## Memorandum

**To:** John Robison, Public Lands Director, Idaho Conservation League; Pete Dronkers, Southwest Circuit Rider, Earthworks; and Judy Anderson, private citizen  
**From:** Ann Maest, PhD; Buka Environmental  
**Date:** 27 October 2020  
**Re:** Evaluation of the Draft Environmental Impact Statement (DEIS) for the Stibnite Gold Project, Idaho, and Related Water Quality Conditions, Predictions, and Effects

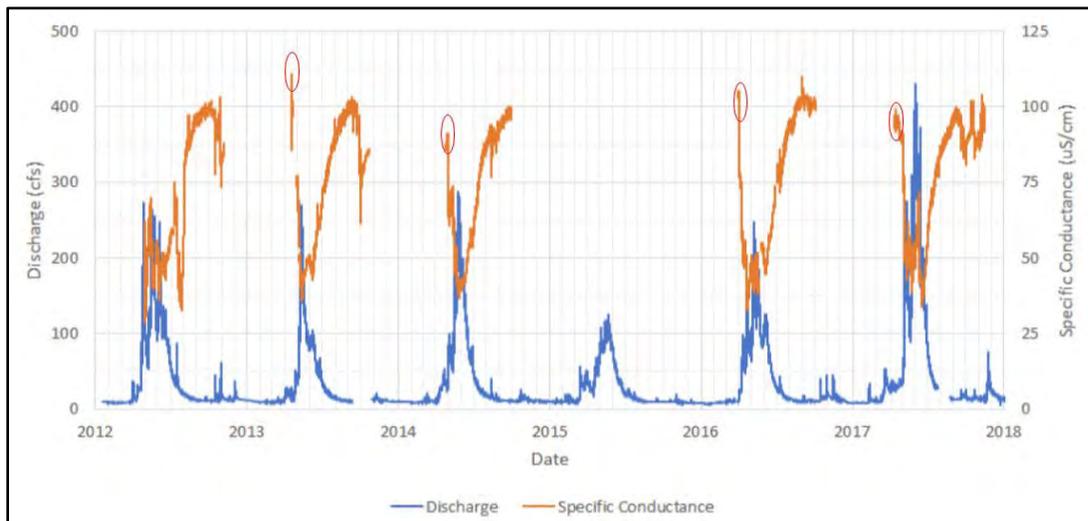
One of the most distinctive features of site surface water quality is the temporal variability in concentrations associated with stream hydrographs. At sites affected by mine contaminants with notable temporal variability, it is important to know the maximum concentrations because they could cause acute, short-term toxicity to aquatic biota, depending on the element and the maximum concentrations. Knowledge of maximum concentrations is also important for assessing the effectiveness of cleanup and mitigation measures. Surface water monitoring is often not frequent enough or well-timed with the snowmelt hydrograph to identify temporal changes and maximum concentrations. As shown in Figure 1a, some samples associated with the rising limb of the snowmelt hydrograph (March – April, depending on the year) were collected, and those samples had the highest antimony concentrations and had high arsenic concentrations. Figure 1b shows conductivity values, which can be measured more frequently in, for example, automatic samplers, and obvious peaks in conductivity also occur on the rising limb of the snowmelt hydrograph.

Because the SWWC model is based on annual average conditions, these temporal changes are not well represented in the model. A “patch job” was done using monthly Seasonal Adjustment Factors (SAFs) to account for the temporal variability, but these adjustments only operate on a monthly level and would not capture peaks that could occur over shorter timeframes (see Section 5.2.2 of this memorandum). The same monthly adjustment factor is used for all years, regardless of interannual peak or other seasonal flow variability. The SWWC model report (SRK Consulting, 2018) states that concentrations were typically lowest during the spring snowmelt when flow rates were highest, and most exceedances occurred during low flow conditions. Figures 1 A and B show that antimony and specific conductance values are often higher during rising flows than high or low flows. Arsenic concentrations are highest during low flow, but not enough sampling was conducted during the rising limb; specific conductance was measured much more often. The high values for specific conductance during the rising limb are an indication that more sampling would have revealed higher contaminant concentrations during the rising limb.

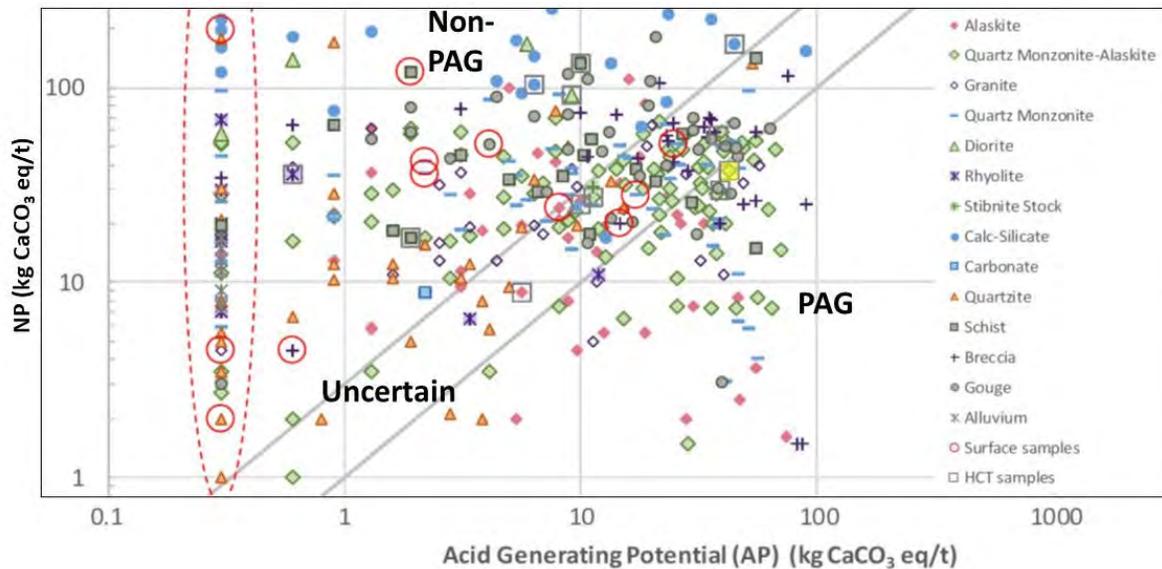
Figure 2 shows that categorizing waste rock based solely on lithology is inadequate. Notice that alaskite, quartz monzonite-alaskite, quartz monzonite, schist, gouge, and breccia samples span from non-PAG to Uncertain to PAG. This is a good indication that more divisions should have been made within the lithologic units (geochemical or geoenvironmental test units) to ensure the units had at least somewhat similar acid-generation and contaminant leaching potential. Quartz monzonite is the most common rock type in the Yellow Pine pit (25%), the Hangar Flats Pit (54%), and the Fiddle DRSF (64%) (DEIS, Tables 4.9-1, 4.9-3).

**Figure 2. NP vs. AP results for different lithologies showing surface and selected HCT samples.** The one PAG sample selected to represent all PAG rock in SRK Consulting’s water quality models (SRK Consulting, 2018) is shown in yellow highlight. The only other PAG sample selected for HCT testing is near this sample (shown in a square) but was excluded from use in the SWWC models.

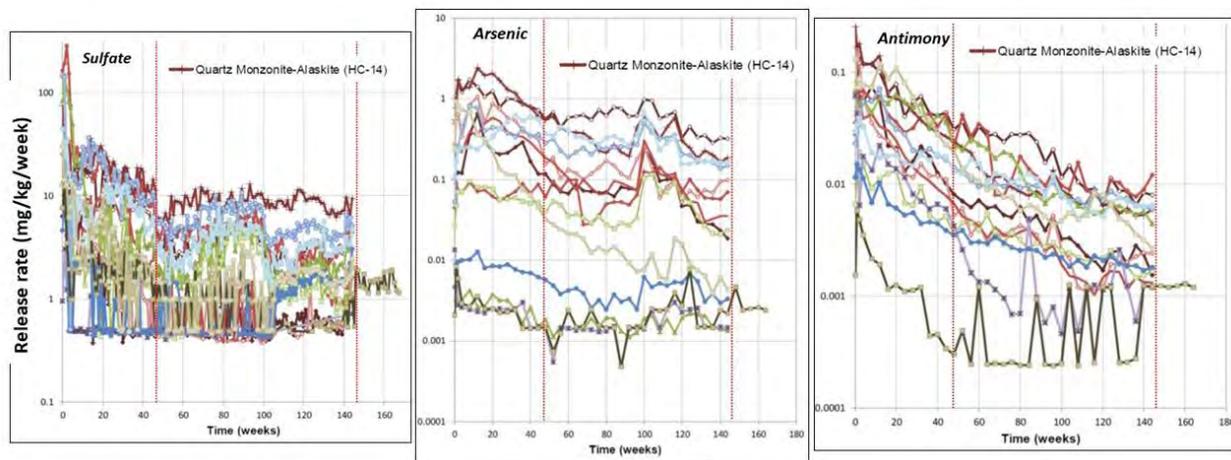
**Figure 3. Release rate trends for sulfate, arsenic, and antimony in HCT samples.** The vertical red lines indicate the weeks chosen for the one PAG sample used in modeling, HC-14, as “steady state” conditions. While the sample has fairly steady sulfate release rates during the selected weeks, arsenic and antimony rates are not steady. Using average rates from these weeks ignores much higher release rates from early HCT week that represent first-flush conditions, as shown in all three graphs. Note that all y axes are logarithmic.

- Average steady-state release rates are used for all analytes for the same weeks that sulfide releases reached steady state conditions. As shown in Figure 3 in this memorandum, steady-state rates were possibly reached for sulfate but not for arsenic or antimony.

**Figure 4. SODA spent ore HCT release rates for arsenic and antimony, Phase 1 and 2 HCT results.**

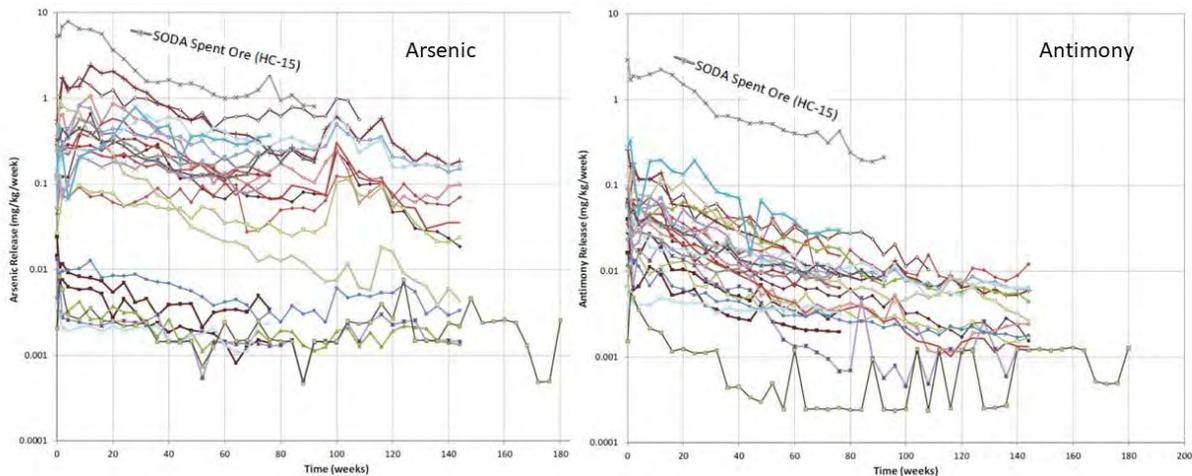
- SODA spent ore HCTs (HC-15, -16, -17) were not used to estimate leaching rates, even though said these are good analogues for future mining and they are planned to be used for construction fill. Results from these samples could be used to represent the variability in releases from the DRSFs, but the SODA materials should not be used as construction fill because they produce very high release rates for arsenic and antimony, as shown in Figure 4.

**Figure 5. Partial conceptual model of the TSF showing movement of consolidation water from all parts of the tailings.**

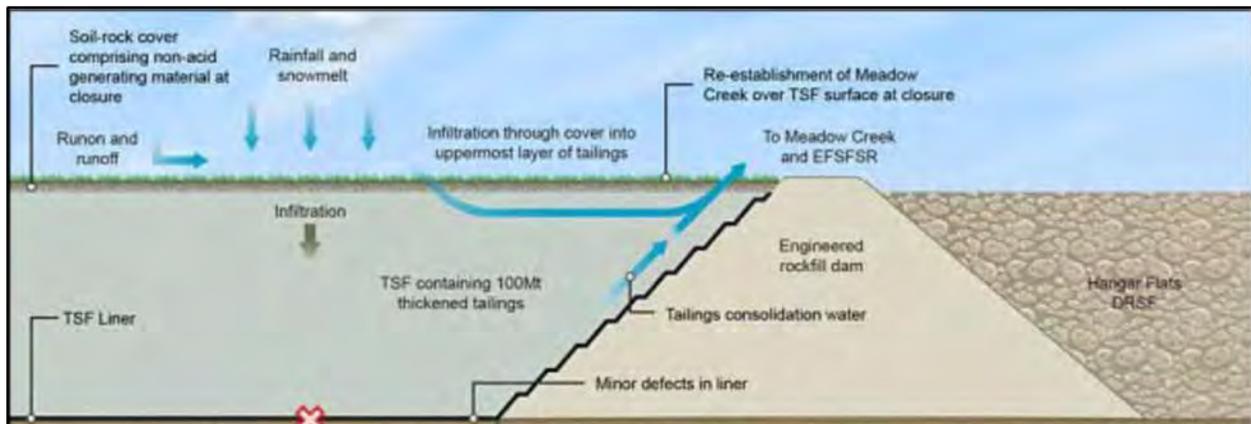
- During post-closure, the results from SPLP leachate are used to estimate the chemical composition of infiltration through the TSF cover. It is unclear from the discussion in SRK Consulting (2018; Section 5.4.1 and Tables 5-3 and 5-4) how these results will be mixed with the chemistry of seepage through the liner. A sensitivity analysis should be conducted that examines a range of assumptions of mixing to evaluate the resulting TSF leachate under the facility.

- Tailings water quality is represented by five tailings streams (DEIS, Table 4.9-9). During post-closure tailings water quality is represented only by the process water chemistry of West End oxide and sulfide tailings, which will be produced in the later stages of mining and will be therefore by on the top of the TSF (DEIS, p. 4.9-19). The TSF model assumes that most consolidation water would be derived from the upper parts of the TSF during post-closure. However, DEIS Figure 4.9-7, reproduced in part in Figure 5 below, shows consolidation water coming from *all* parts of the tailings and moving upward. Infiltration water may only affect the upper materials, but consolidation water comes from the entire column.

**Figure 6a. Arsenic MWMP leachate concentrations vs. percent sulfide sulfur.** Arsenic MWMP leachate concentrations (SRK Consulting, 2017b, Figure 3.42) also show elevated concentrations (above the water quality criterion) at low percent sulfide sulfur values.

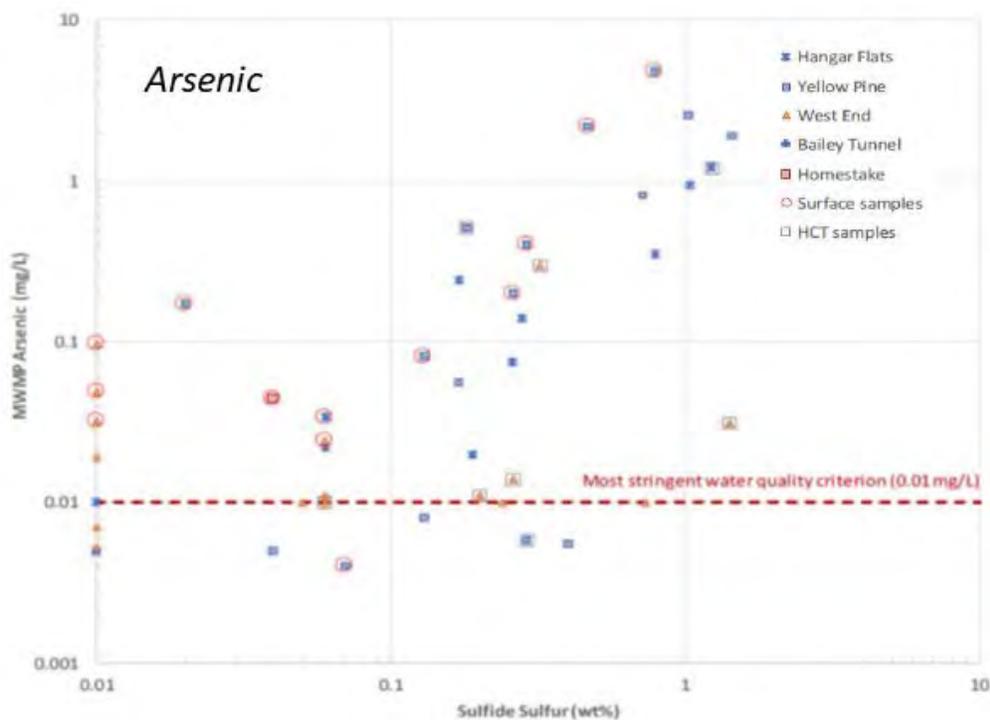
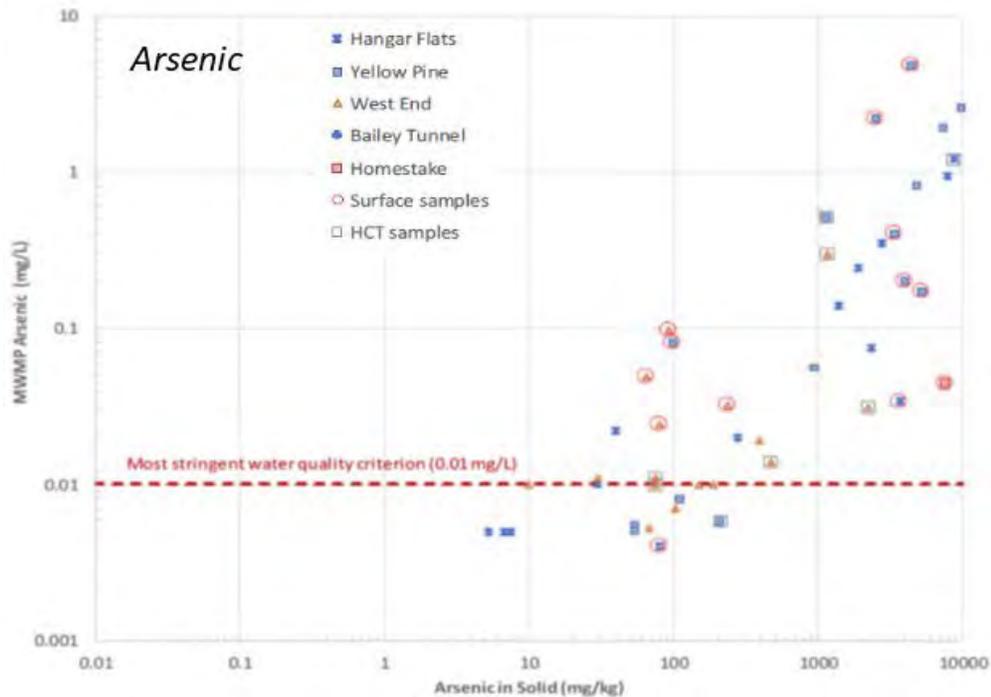
**Figure 6b. Arsenic MWMP leachate concentrations vs. concentration in solid.** Antimony MWMP leachate concentrations (SRK Consulting, 2017b, Figure 3-44) also show elevated concentrations (above the water quality criterion) at low total concentrations in the solid.
